FSN Ref: PM6/SS13/FSN

FSCA: PM6/SS13/FSCA

Urgent field safety notice Easymoov6 enteral feeding pump Safety information

APPENDIX 1

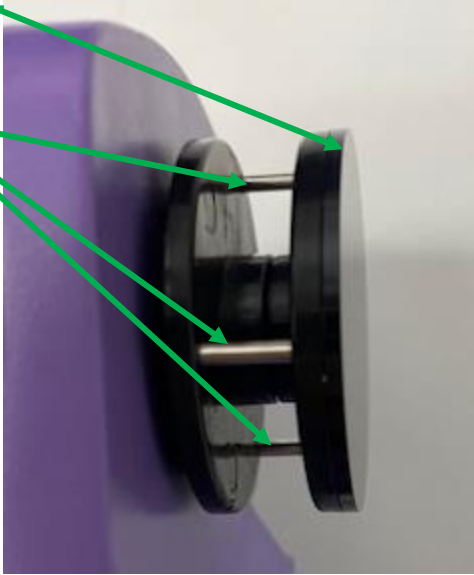
2 Reason for safety corrective action in the field (FSCA)* (in French)	
2	1. Product problem description
	Medwin has been informed of an incident involving an Easymoov6 enteral nutrition pump. The pump's rotor no longer had the rollers required for rotary peristalsis, which can lead to significant overflow.
2 .	2. Risks behind the CASF
	Risk of serious digestive problems caused by a too fast feeding.
2	3. Probability of a problem occurring
	The problem may arise if the following steps occur chronologically: <ol style="list-style-type: none"> 1. The screw holding the two rotor flanges is unscrewed by a third party. 2. Both flanges are stressed and come loose, 3. The rollers are released from their housing and fall
2	4. Foreseeable risk for patients/users
	Overeating and severe digestive disorders, including vomiting.
2	5. Additional information to help characterize the problem
	N/A
2	6. Context of the question

Operating rotor	
<ul style="list-style-type: none"> Retaining screw tightened 3 rollers

Faulty rotor	
<ul style="list-style-type: none"> Loose retaining screw No rollers

3.	3. Type of action to mitigate risk*.	
3.	1. Measures to be taken by the user* <input checked="" type="checkbox"/> Identify the device <input type="checkbox"/> Quarantine the device <input type="checkbox"/> Return device <input type="checkbox"/> Destroy device <input checked="" type="checkbox"/> Modify/inspect device on site <input type="checkbox"/> Follow recommendations for patient management <input type="checkbox"/> Take note of modification/strengthening of instructions for use (IFU) <input type="checkbox"/> Other <input type="checkbox"/> None <ul style="list-style-type: none"> • Identify pumps whose rotor does not have the 3 rollers required for correct pump operation. (See pictures in annex) • Immediately repair the pump. Contact your local Vygon representative to arrange rotor replacement if necessary. • Make nursing staff aware of the problem, so that they check the rotor before feeding. • Remind staff that : <ul style="list-style-type: none"> - Any dismantling of the rotor, for cleaning purposes for example, must be carried out by a competent and trained member of the plant, - The use of the automatic purge function at each tubing change also reveals any occlusion defects in the rotor.

3.	4. Does the customer have to reply? * (If yes, form attached specifying deadline for return)	Yes
3.	5. Measures taken by the manufacturer <input type="checkbox"/> Product withdrawal <input type="checkbox"/> Modification/inspection of device on site <input type="checkbox"/> Software update <input type="checkbox"/> Modification of IFU or labeling <input checked="" type="checkbox"/> Other <input type="checkbox"/> None The rotor assembly method used in production has been modified to avoid separating the flanges and freeing the rollers.
